Anthropomorphic Test Devices; Hybrid III 6-Year-Old Child Test Dummy

ACTION: Notice of proposed rulemaking (NPRM).

SUMMARY: Today's NPRM proposes two changes to the agency's specifications for the Hybrid III six-year-old child dummy. In Part 1 of this NPRM, to improve the durability of the dummy's femurs, we propose changes to the design of and material used for the femur assembly. In Part 2, the drawing for the abdomen insert would be corrected so that the abdominal insert dimensions on the drawing reflect the actual part. Part 2 of this rulemaking commenced in response to a petition for rulemaking submitted by Denton ATD (Denton) and First Technology Safety Systems (FTSS). This document declines the petitioners' suggestion to investigate tolerances for vinyl and rubber components of the dummy and to specify the expected time frame each part would meet the tolerances.

Figure 1: Illustration of femur assembly

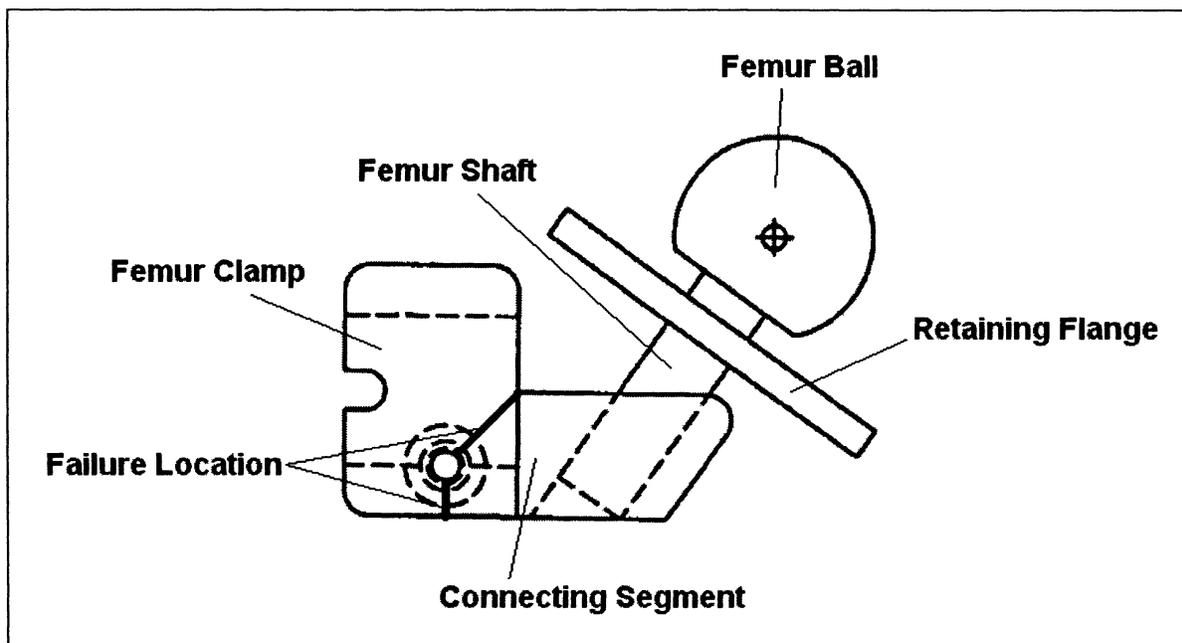
Failures of the HIII-6C femur appear to have initiated at a sharp corner between the femur clamp and connecting segment sections of the machined femur. The fracture was observed from this corner to the bolt hole within the femur clamp, at an angle of approximately 45°. The failure continued through the thin section of material directly beneath the bolt hole, causing complete separation of the machined femur. Additionally, in one failed component, small indents on the inner diameter of the retaining flange were observed, indicating potential contact between the flange and shaft. The location of the fracture is depicted in the Figure 1 illustration. Pictures of

The proposed modification to improve the femur’s durability is based on the approach developed by FTSS. The agency decided on that approach over Denton’s because the FTSS design was more straightforward and simpler than that of Denton,⁶ and a similar design change had demonstrated improvement in the HIII-10C. Rather than re-designing, FTSS increased the strength and durability of the femur assembly by fabricating the machined femur and shaft from 4340 steel, which has a higher yield strength than the

original material, aluminum bronze C-624 AMC0-18, while keeping the ball and retaining flange as the original aluminum bronze material. A ¼-inch (6.35 mm) circular fillet was added between the femur clamp and the connecting segment to eliminate stress-risers that were present on the original femur, and a portion of the connecting segment material near the femur clamp was removed. The weight of the new FTSS femur is only 0.002 lb (0.001 kilograms (kg)) heavier than the original femur. Table 1 below compares the weights and material properties of the original femur, the FTSS-developed femur, and the Denton-developed femur.

To implement this change in femur design and material, the following changes would be made to the materials describing the HIII-6C in 49 CFR Part 572. Drawings 127-3017-1&-2, "6 YR H3—FEMUR MACHINED" would be replaced with drawings 127-3017-1S&-2S, which show the proposed machined femur.⁷ The femur assembly drawings (127-3016-1&-2) would also be changed due to the new femur design, with new part numbers 127-3016-1S&-2S. Higher assembly drawings including 127-3000, "LOWER TORSO ASSEMBLY," and the complete assembly drawings (127-0000) would be amended to show the proposed part. These revisions would be noted on drawing SA572-127DRL-2. The PADI would also be updated so that it shows the proposed machined femur in figures and reports the proper lower torso assembly and total weight for the dummy. Finally, the part numbers for the machined femur and the femur assembly would be changed in the Parts/Drawings list, along with the revision letters for higher assembly drawings, as appropriate. Copies of the HIII-6C drawing package, PADI, and Parts/Drawings list that include the proposed change in femur design can be obtained online at <http://www.regulations.gov>, in the same docket as this NPRM.
